Subject: WT-0151 Ozone System Expansion/Upgrades Hefner WTP  
DWSRF Project No. P40-102092-09 and P40-1020902-10  
**Letter of Approval PCO-033\_Chemical Feed Vault Replacement**

Subject: Potential Change Order (PCO-033) – Chemical Vault Feed Vault Replacement  
Project WT-0151 – Ozone System Expansion/Upgrades at the Hefner Water Treatment  
Plant  
**DWSRF Project No. P040-1020902-09 and P040-1020902-10**

Attachment A – Modifications to Contract Drawings

## ATTACHMENT A – Modifications to Contract Drawings

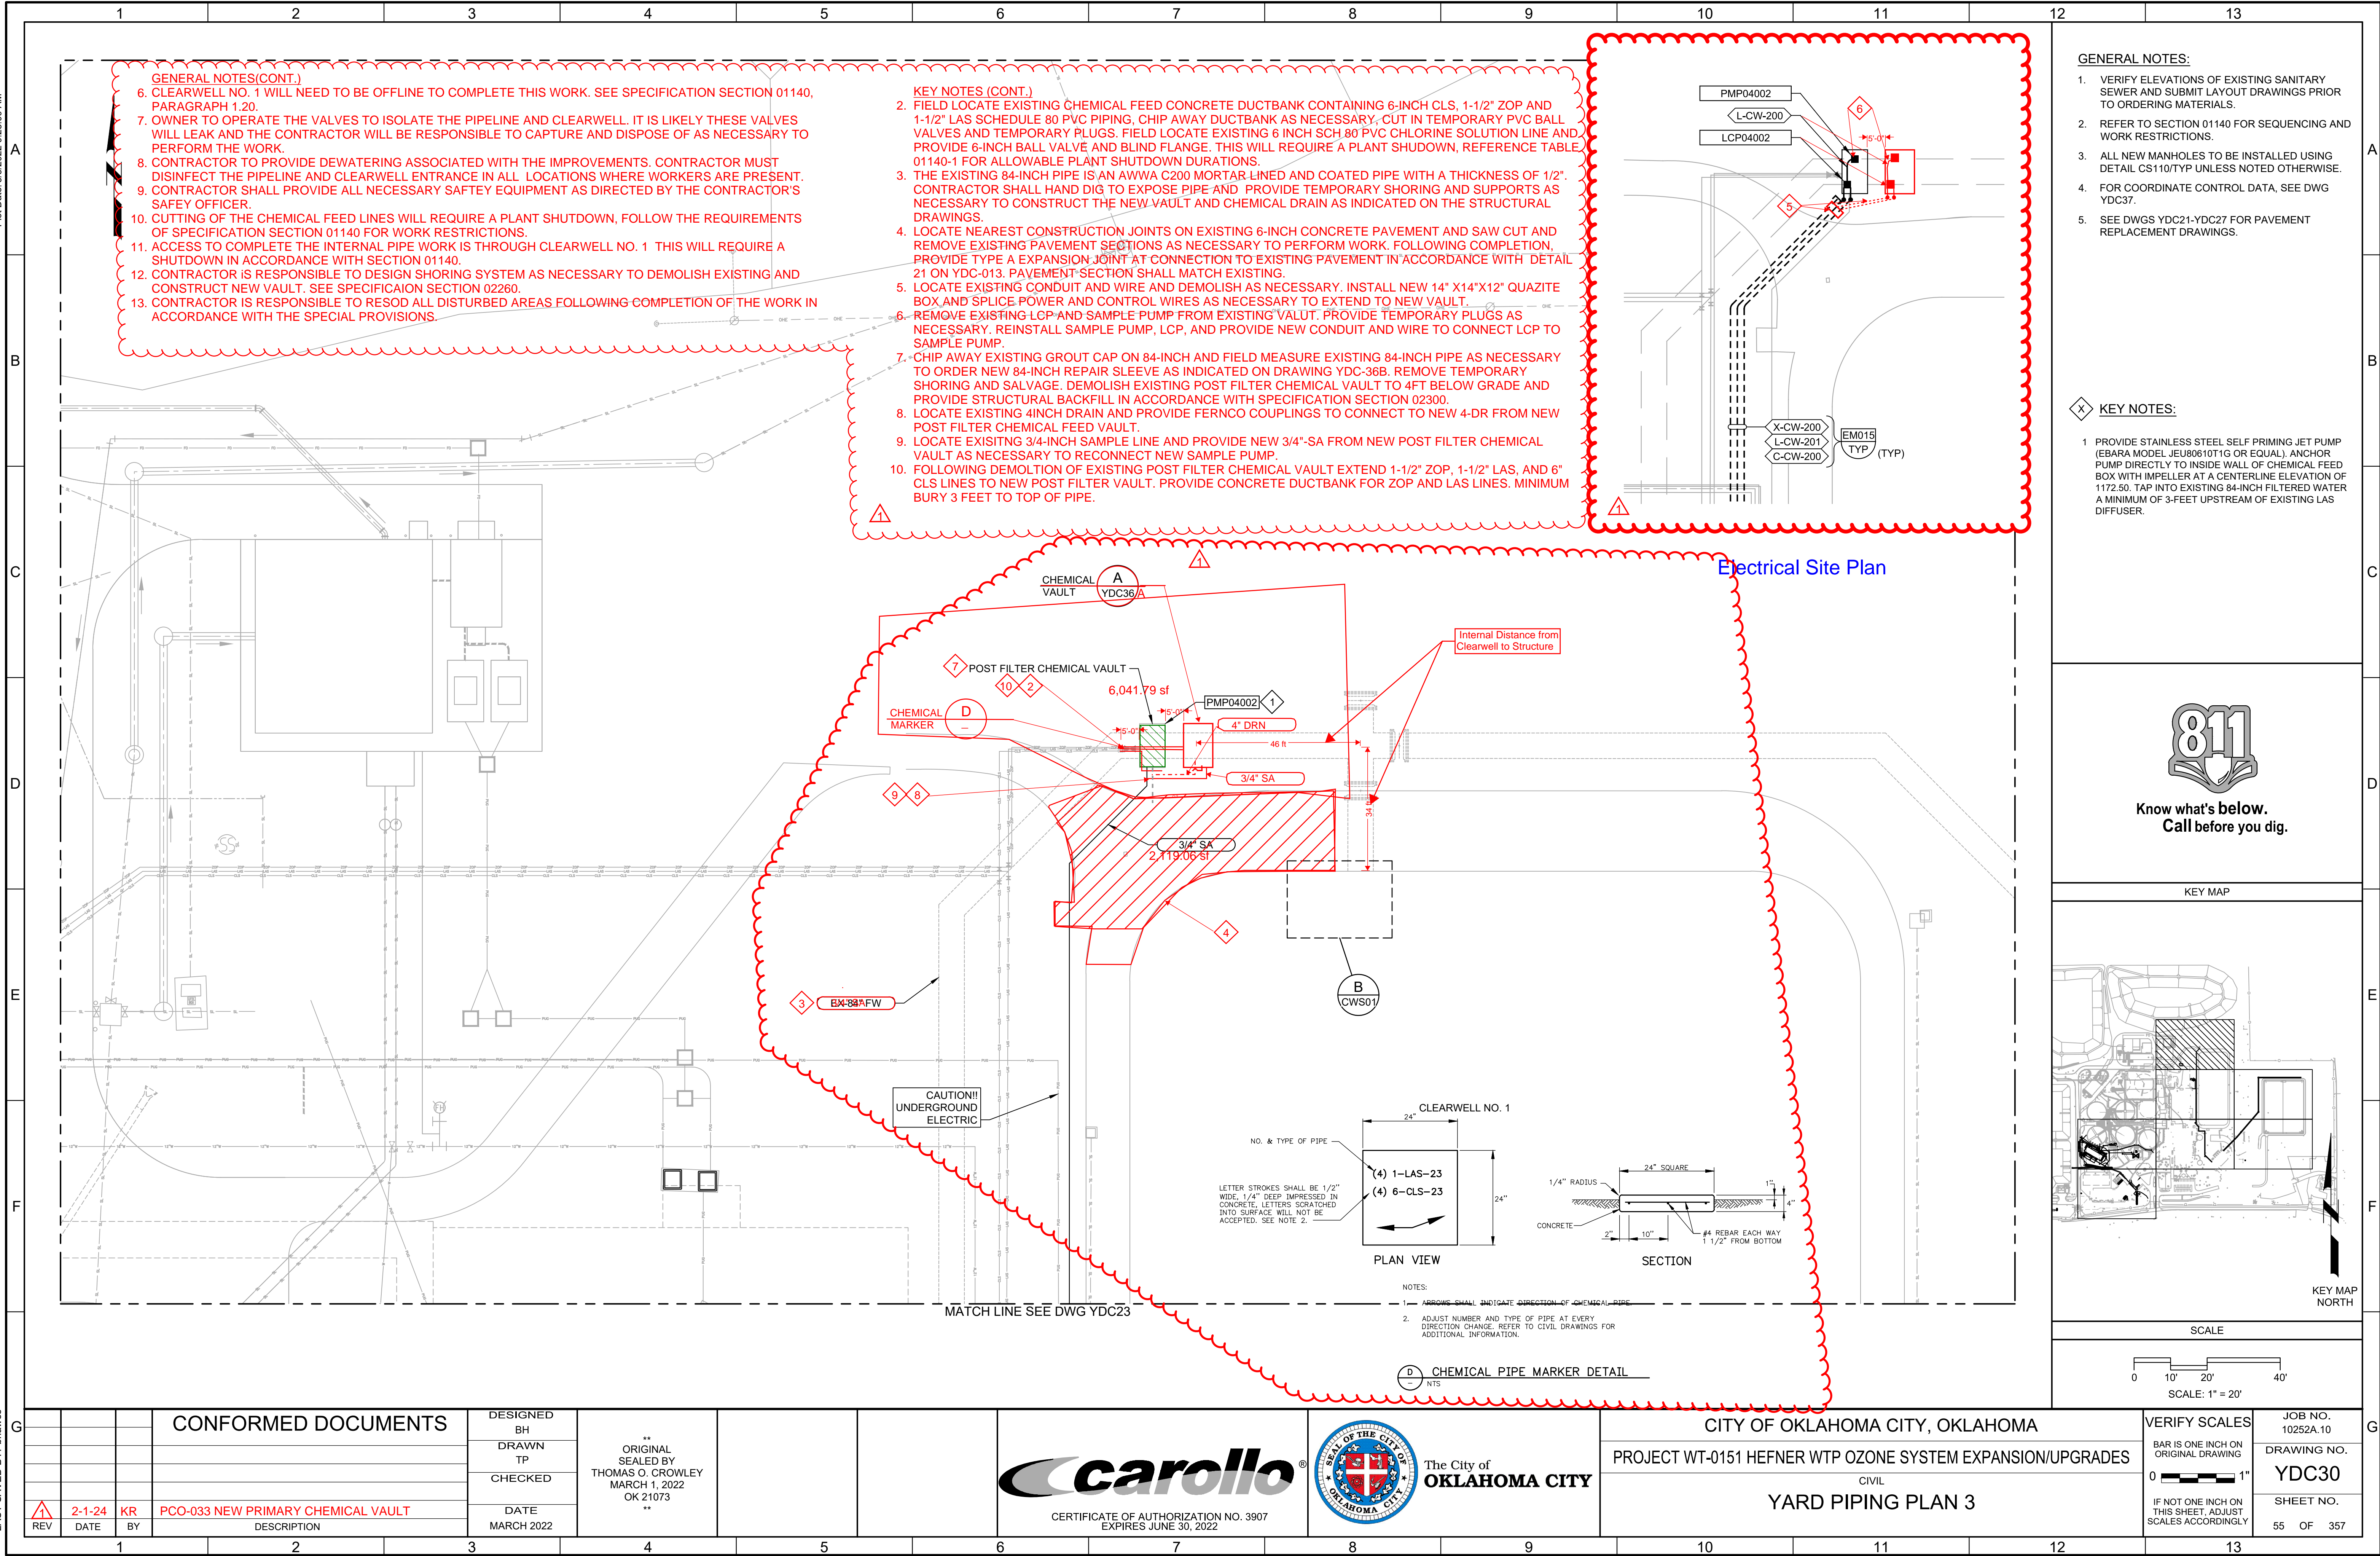
1. Excavation, shoring, dewatering, and temporary piping supports as necessary to construct a new cast in place concrete chemical feed vault to replace the existing deteriorated precast concrete chemical feed vault on the existing 84-inch filtered water pipe. This will permit continued safe access to the chemical vault where ZOP, LAS, and CLS is injected prior to entering the clearwells.

2. Relocation of ¾"SA, 1-1/2"-LAS, 1-1/2"-ZOP, 4"-DRN, and 6"-CLS yard piping to connect from existing vault to new chemical feed vault. Including all temporary valves, piping necessary for sequencing.

3. Relocation of the sample pump and control panel and extension of conduit/wires and ¾" SA piping necessary to install, test, and commission sample pump with new analyzers installed as part of this project.

4. Installation, testing, and commissioning of new 1-1/2"-ZOP, 1-1/2" LAS, and 6"-CLSdi insulated piping, valves, and diffusers inside the new cast in place concrete vault.
